Staff Report

Meeting Date: February 27, 2020 (Prepared February 20)

Item: 1785 N. Front Street “Woodburn High School” (CU 2019-07, DR 2019-13, EXCP 2019-07, & PP 2019-03)

1 SITE PLAN - CONDITIONAL USE - OVERALL EXISTING
1" = 100'-0"

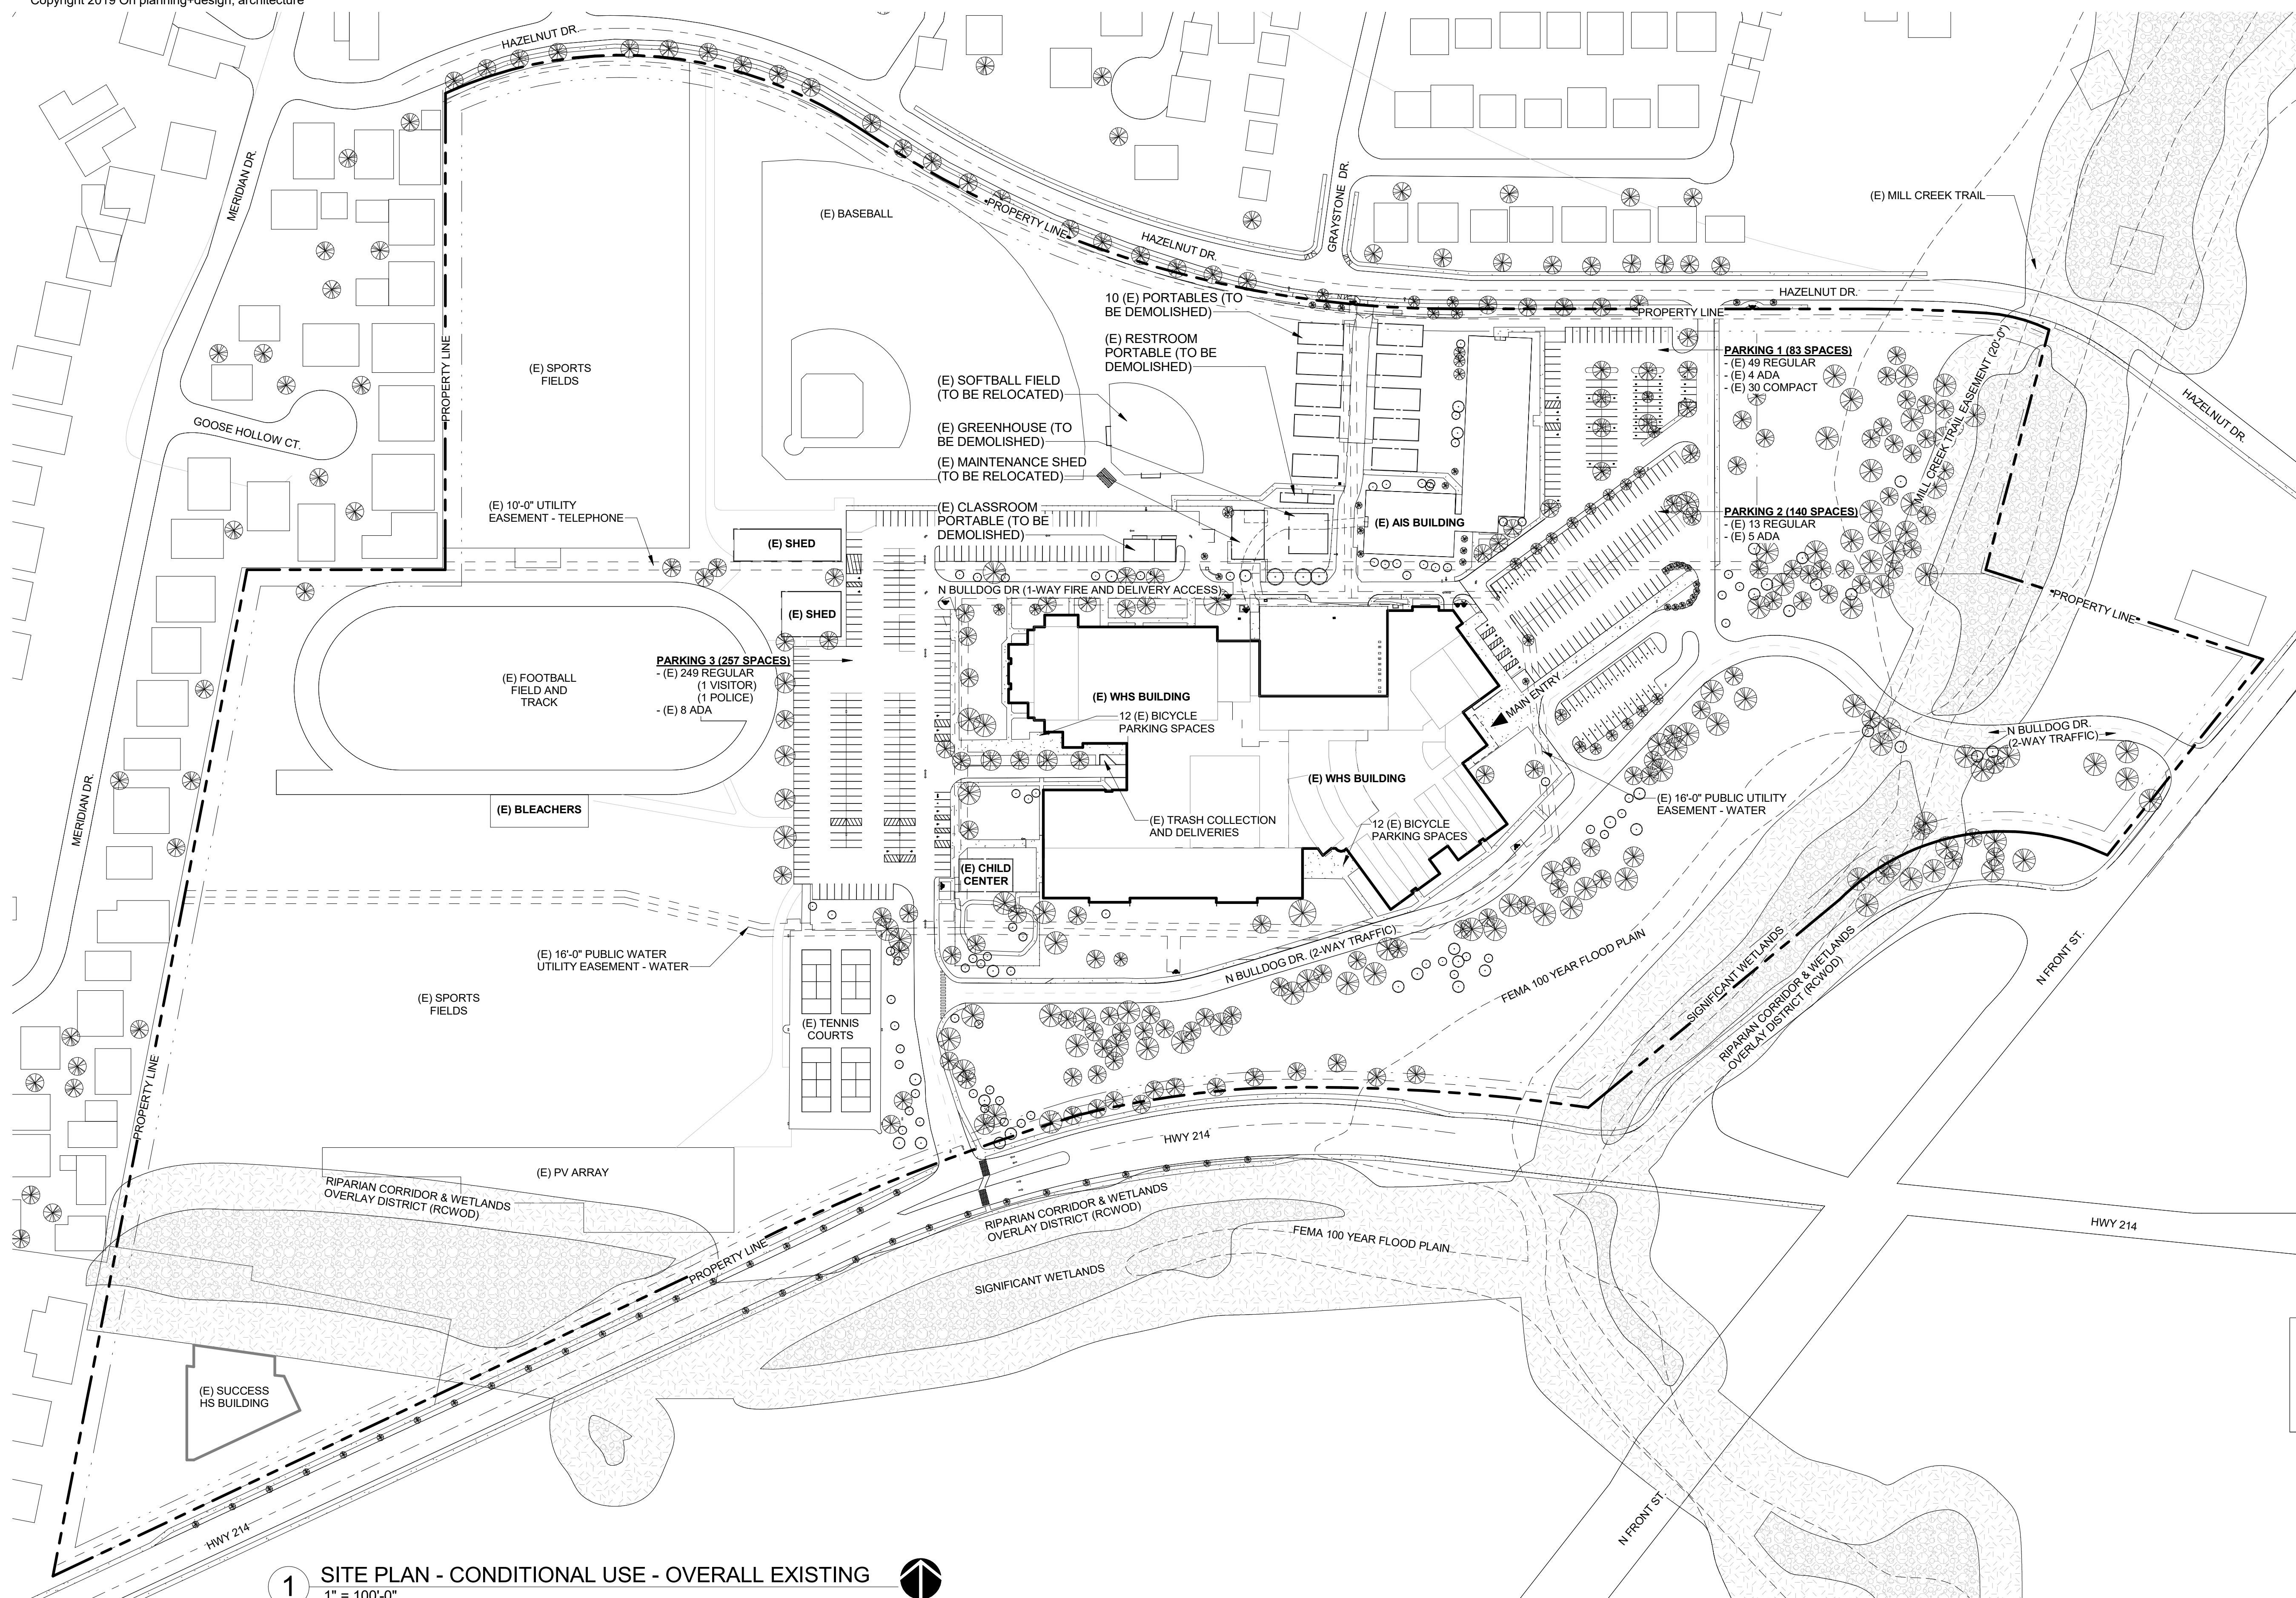
C9. Modular buildings / modulars: Consistent with the land use review plan set submitted February 4, 2020, Sheets CU-A00 Overall Existing Site Plan and CU-A01 Overall Master Plan, the number of modular buildings shall decrease by at least ten (10) by Phase 1. The removal of modular buildings is due by building permit final inspection for Phase 1. (The City may later supersede this condition by taking action on a future land use application submittal as to allow one or more modular buildings.)

1 SITE PLAN - CONDITIONAL USE - MASTER PLAN
1" = 50'-0"

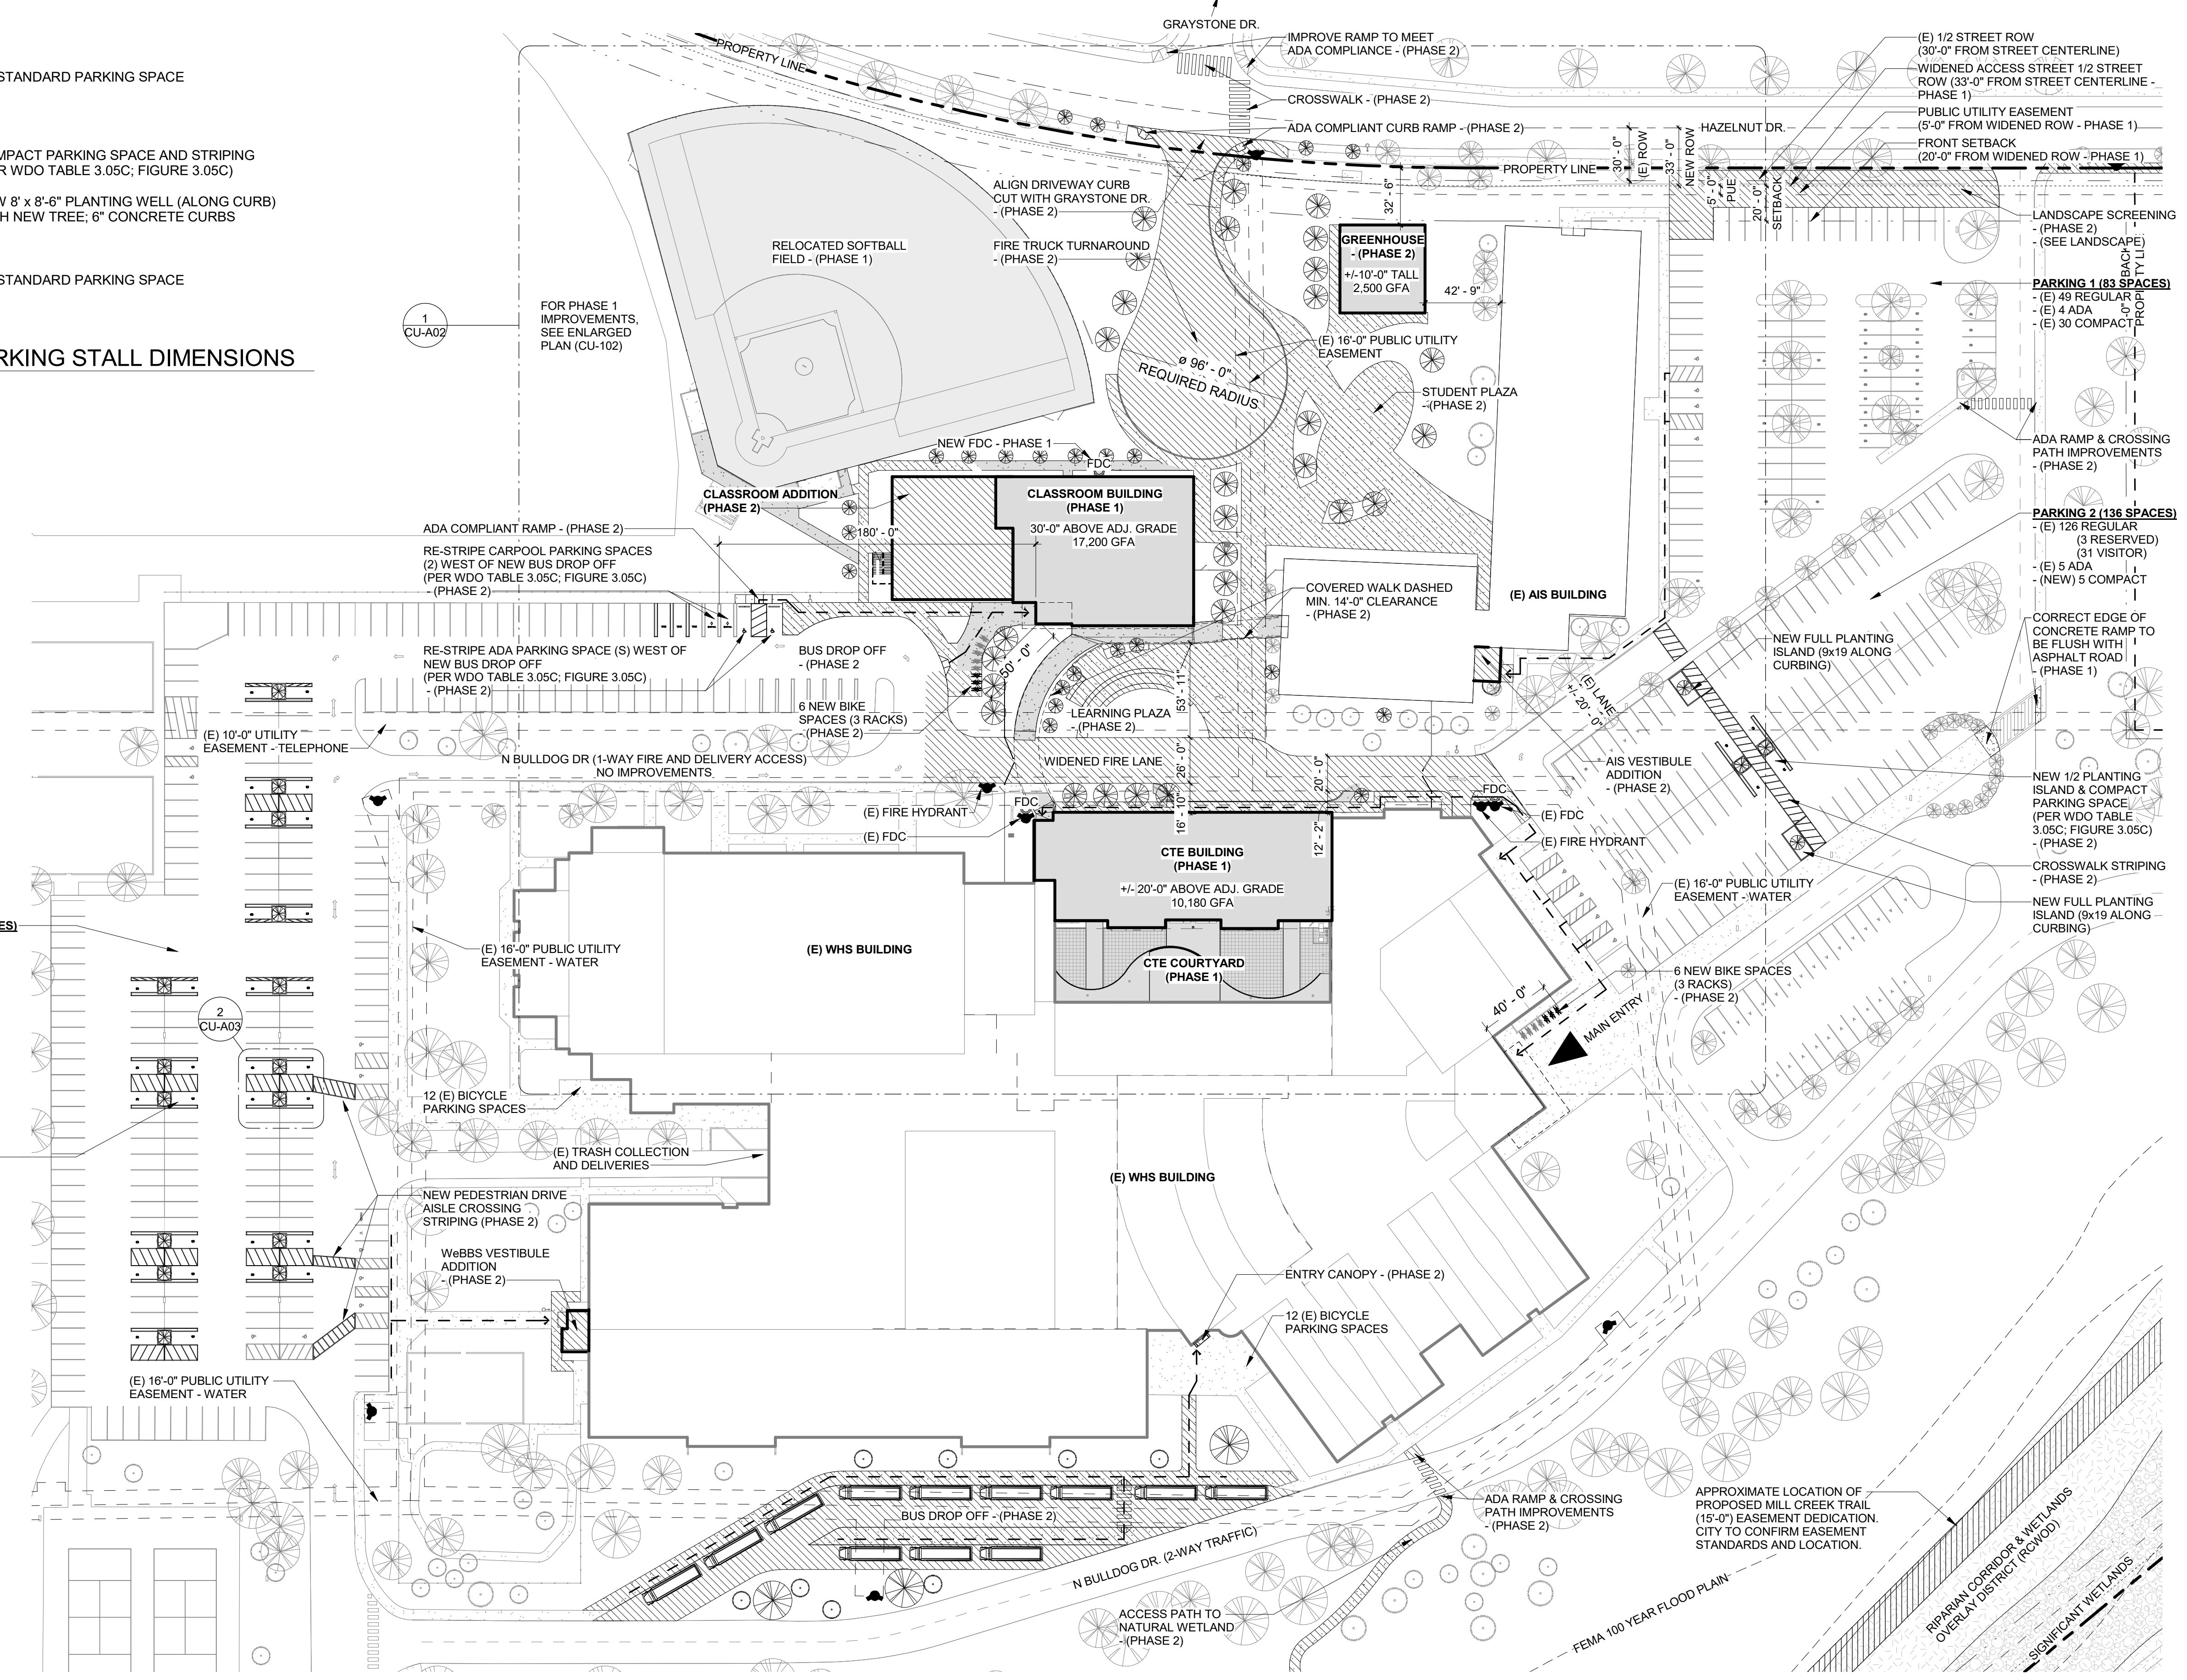
- a. East front student/visitor: As proposed, per Sheets CU-A01 & 3 and L01 & 2, the applicant shall modify the parking area to stripe a walkway at least six (6) feet wide across the drive aisles and install and plant four landscaped islands with trees. The middle two islands shall each be at least fifty-two (52) square feet within inside of curbing with narrowest dimension of six-and-a-half (6½) feet minimum within inside of curbing. The trees shall conform to Table 3.06B. Additional or altered compact stalls shall be striped with "C", "COMPACT", or "COMPACT ONLY".

EX2. Hazelnut Drive: The required improvements shall be per the land use review plan set submitted February 4, 2020, Sheets CU-A01 & 3 and L01.

EX3. N. Front Street: The required improvements shall be per the land use review plan set submitted February 4, 2020, Sheets CU-A01 & L01.

EX4. Highway: The required improvements shall be per the land use review plan set submitted February 4, 2020, Sheets CU-A01 & L01.

- a. Number: The City acknowledges the phasing plan of two Phases 1 & 2.
- b. Improvements by phase:
 - i. Improvements are due by the phases with which they are associated as noted and delineated per the revised land use review sheets submitted February 4, 2020: CU-A01, 2, & 3 and CU-L02.

The overall site plan, Sheet CU-A01, tabulates Phase 2 having a sitewide net result of 477 parking spaces and states that as applied to the site by end of Phase 2, minimum required parking is 377 spaces. The proposal exceeds the minimum.
